ADDENDUM

ADDENDUM NO.: 02
PROJECT NAME: Kenwood Academy Link and Mechanical (Rebid)
PROJECT NO.: 05326
CONTRACT NO.: C1602R
DATE OF ISSUE: February 29, 2024

NOTICE OF CHANGES, MODIFICATIONS, OR CLARIFICATIONS TO CONTRACT DOCUMENTS

ENLARGED E.L.C. ROOM PLAN, SCHEDULES AND DETAILS

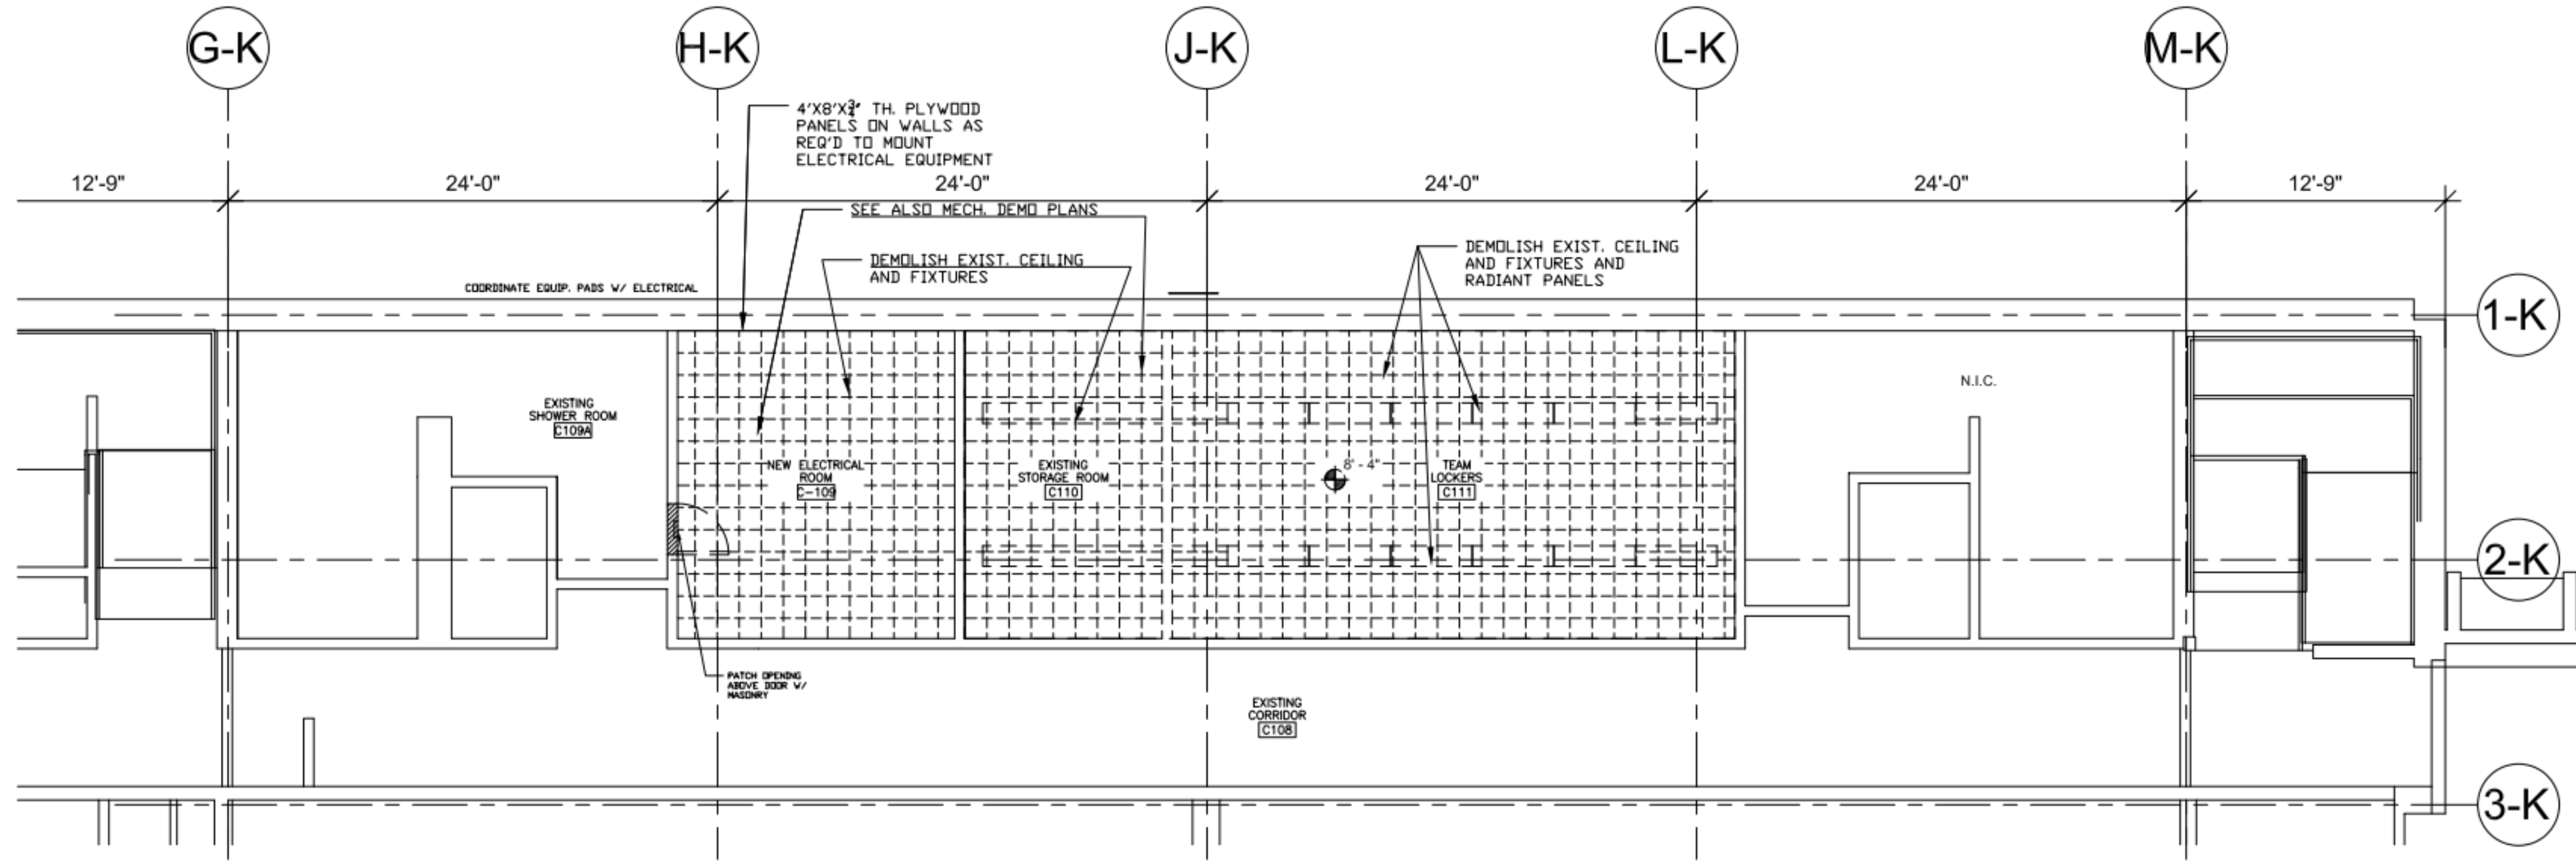
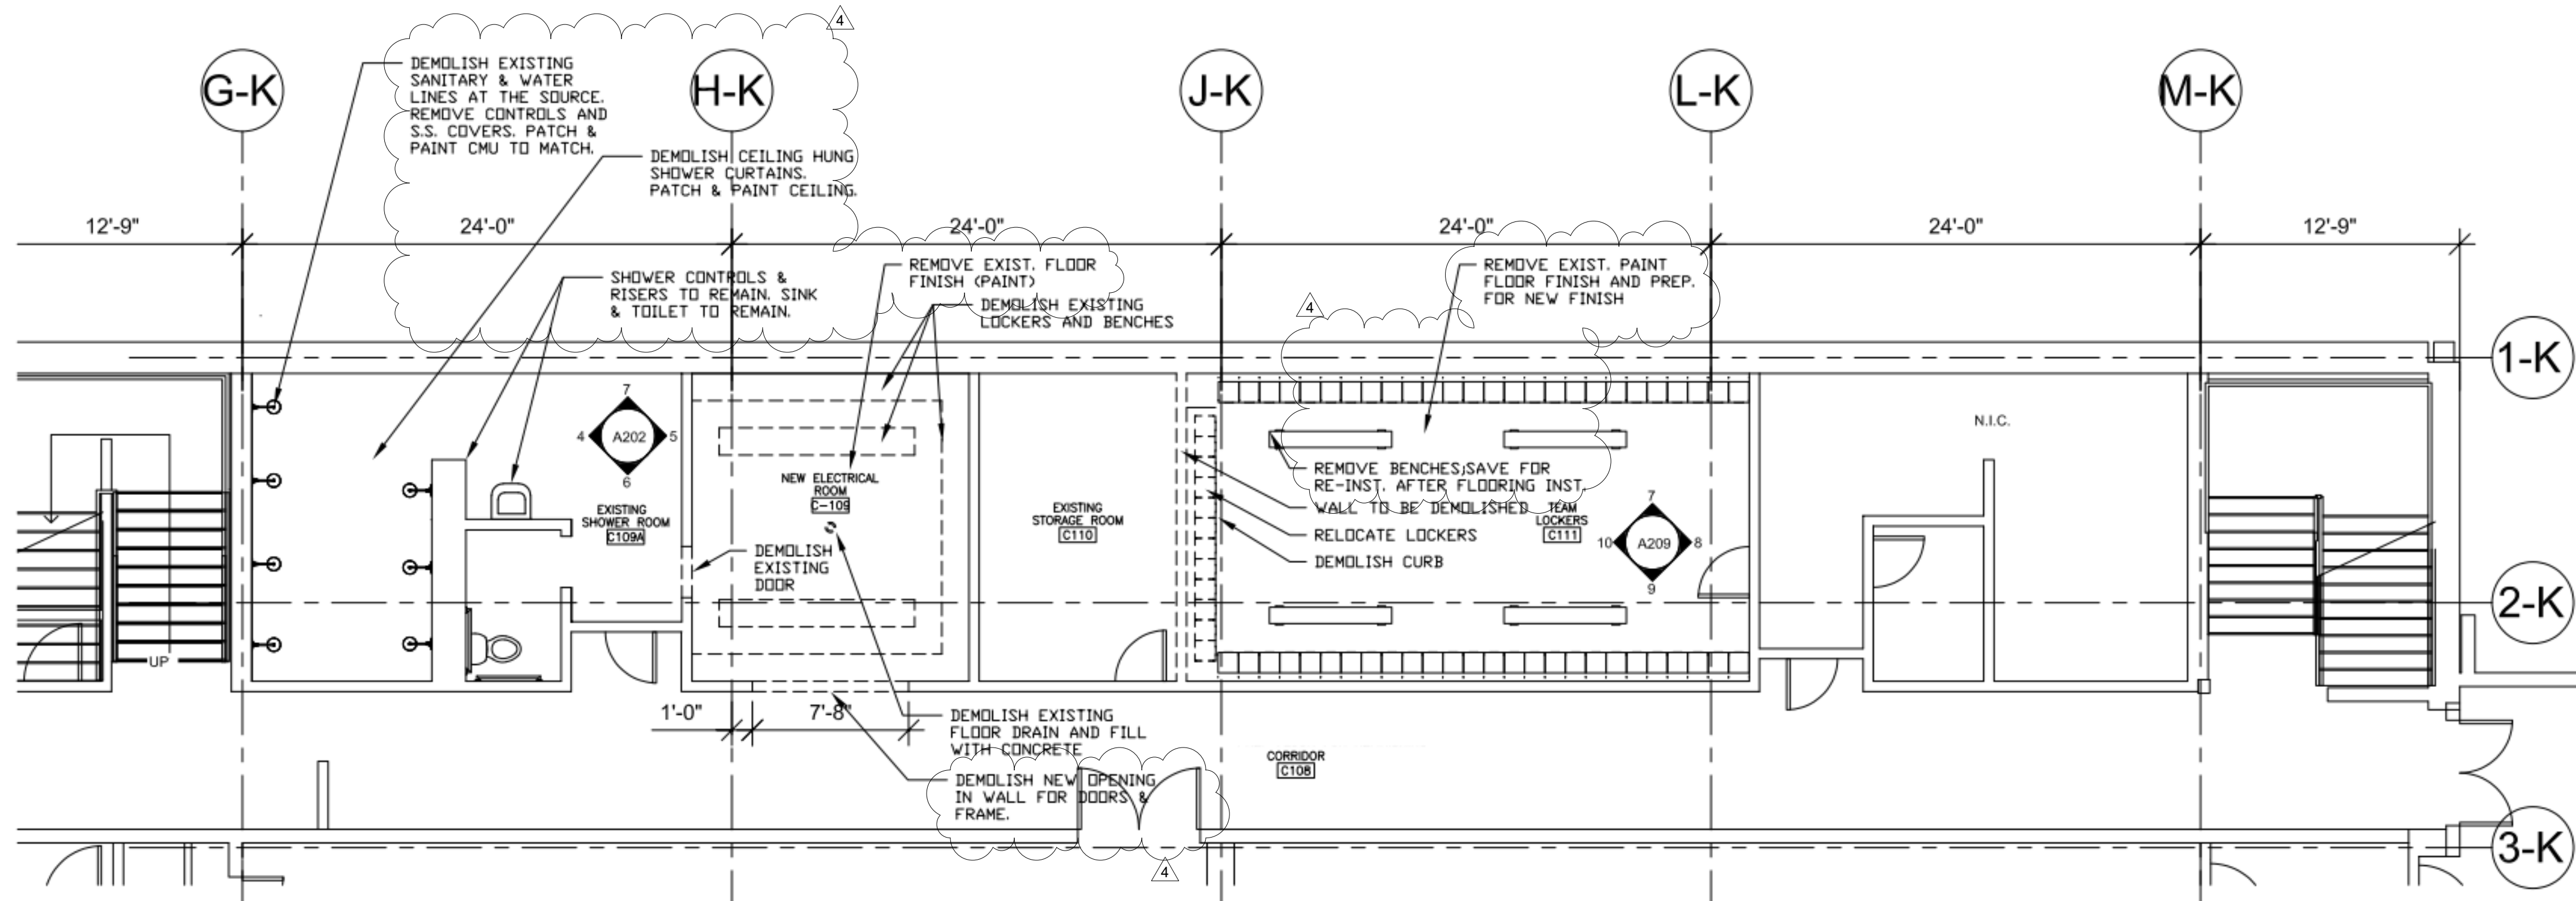
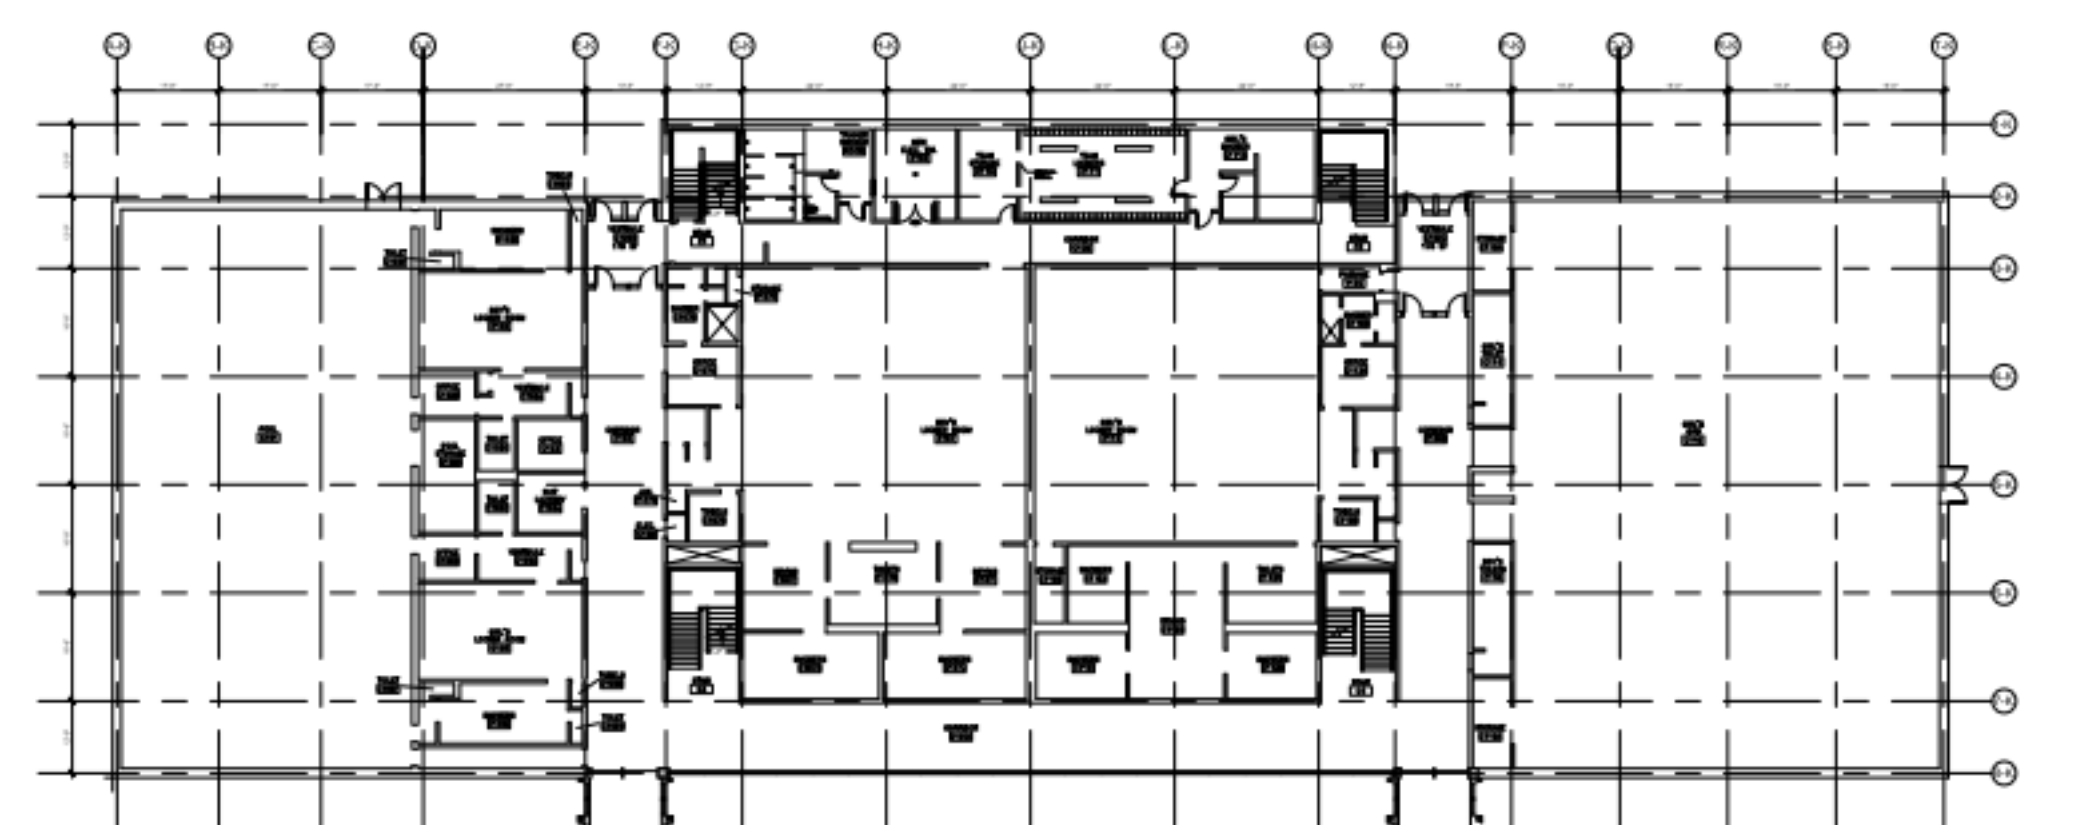
- Change 10** A201 - ENLARGED ELC- ROOM PLAN, SCHEDULES AND DETAILS; **REVISED** to add additional notations regarding demolition plan
- Change 11** A605 - PARTITION TYPES; **REVISED** to add information regarding partition types and add partition type E.

Question: (Regarding Trainer and Locker Room Renovation) On sheet A201, in the existing locker room to be converted to the Electrical Room, please advise what is the existing flooring finish to be removed. Is it ceramic tile, VCT, epoxy, etc.

Question: (Regarding Trainer and Locker Room Renovation) On sheet A202, the Trainer and Boy's Locker Rooms call for a new tile floor, on sheet A201, neither of these rooms require the removal of the existing floor system. Please advise if the existing floor finish in these rooms are to be removed. If so, what is the floor finish.

Question: (Regarding Trainer and Locker Room Renovation) On the contrary, the floor finish on sheet A201 for the Team Locker Room reads PT-2, I assume this to be painted floor, but sheet A202, indicates the finish floor to be tile. Please advise.

Response: [The existing concrete floor is painted. Remove paint and prep surface for new finish. Please refer to revised sheet A201 included in this addendum.](#)

Response: [Please refer to sheet A201 revised and included in this addendum.](#)

Response: [Please refer to sheet A201 revised and included in this addendum.](#)
